**Correction Notice #2: STRUCTURAL**

**Project Address** 423 2<sup>nd</sup> Ave Ext S  
Seattle WA 98104  
**Project No.** 6508387  
**Sender** Matt Aalfs, BuildingWork  
matt@buildingwork.design

Subject: Geotechnical Report Review Letter  
Metropole Building Redevelopment  
421 2<sup>nd</sup> Avenue Extension South  
Seattle, Washington  
File No. 24937-001-00

Figure 1

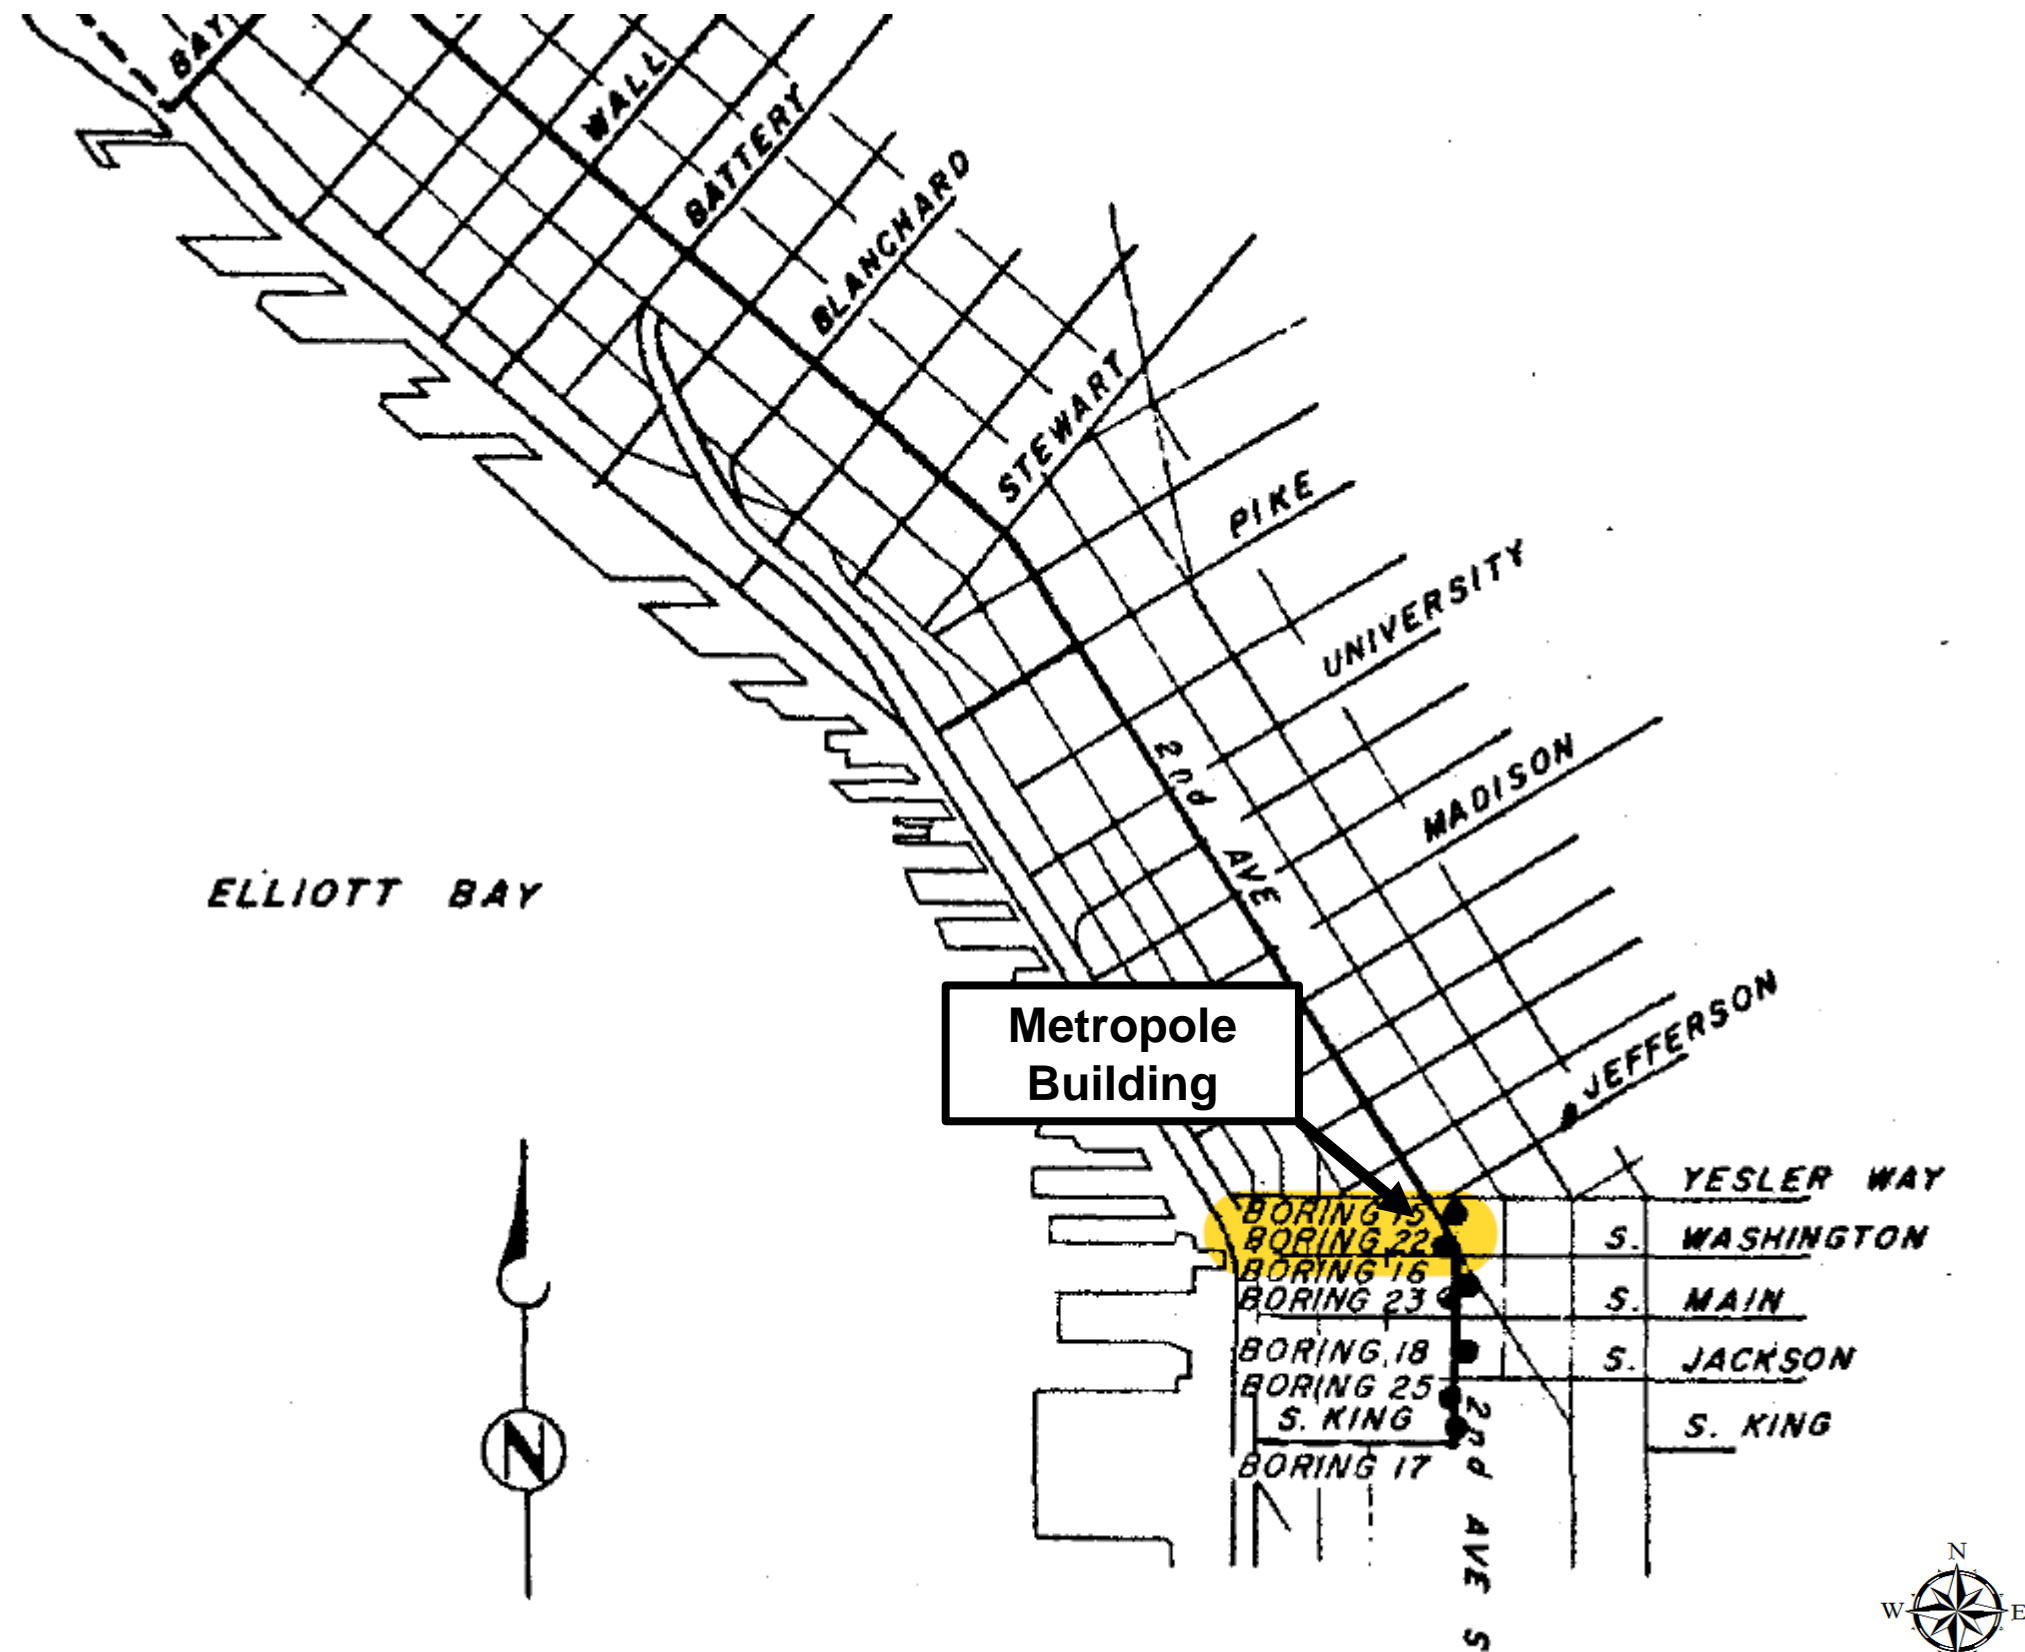
1. We are in general agreement with the subsurface characterization provided by ADAPT Engineering where the borings were drilled at the northern end of the building. We reviewed additional existing geotechnical information prepared by Metropolitan Engineers (1966) and Shannon & Wilson (2004). Site plans and selected borings from these projects are presented as attachments to this letter. Existing boring logs (DT-201 and B-22) are available near the southern end of the Metropole Building. The additional borings demonstrate that the contact to dense to very dense glacially consolidated soils ranges up to 37.5 feet below 2<sup>nd</sup> Avenue South grades. We recommend that the unbonded micropile length extend to at least 37.5 feet below 2<sup>nd</sup> Avenue South grades for P1 through P8 in the south part of the building. Alternatively, additional explorations may be completed to assess the depth to dense to very dense glacially consolidated soils.
